Access Compliance Report

Public Rights-of-Way

Intersection ID: 18787	Main Street: MONROE_RD	Cross Street: WOODBERRY_RD	Location: NW
ADA ID: AFFD0B8FD46A	Ramp Type: PerpDiag	Initial Pass/Fail: Fail	Overall Compliance: No
			Severity Score: 13.75

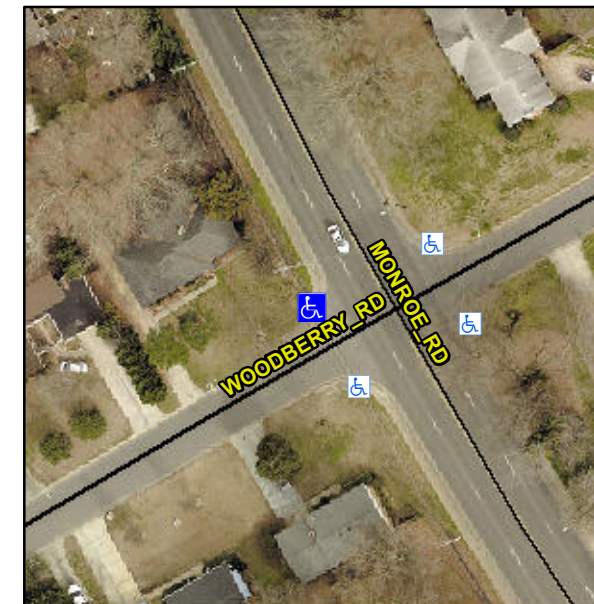
Not Found, R304.2.2, R304.5.3

Compliance	Description	Data	Compliance	Description	Data
N/A	Ramp Length (in)	59.0	No	Ramp Slope (%)	9.8
Yes	Ramp Width (in)	48.0	No	Ramp XSlope (%)	4.2
N/A	Flare Type LT	N/A	N/A	Flare Type RT	N/A
N/A	Flare Slope LT (%)	N/A	N/A	Flare Slope RT (%)	N/A
N/A	Flare Traversable LT?	N/A	N/A	Flare Traversable RT?	N/A
N/A	Landing Length (in)	N/A	N/A	DWS Provided?	N/A
N/A	Landing Width (in)	N/A	N/A	DWS Contrast?	N/A
N/A	Landing Slope (%)	N/A	N/A	DWS Length (in)	N/A
N/A	Landing X Slope (%)	N/A	N/A	DWS Full Width?	N/A
N/A	Landing Curb? (Y/N)	N/A	N/A	DWS Offset (in)	N/A
N/A	Shared Landing?	N/A			
N/A	Gutter Ponding?	N/A	N/A	Gutter Slope (%)	N/A
N/A	Gutter Lip Ht (in)	N/A	N/A	Gutter X Slope (%)	N/A
N/A	Painted X Walk1?	No	N/A	Painted X Walk2?	No
	X Walk 1 Direction	To SE		X Walk 2 Direction	To NE
N/A	X Walk 1 Width (in)	N/A	N/A	X Walk 2 Width (in)	N/A
	X Walk 1 Slope (%)	2.6		X Walk 2 Slope (%)	1.5
	X Walk 1 X Slope (%)	3.5		X Walk 2 X Slope (%)	0.5

Remove & Replace Curb Ramp With Two New Directional Ramps or Equivalent.
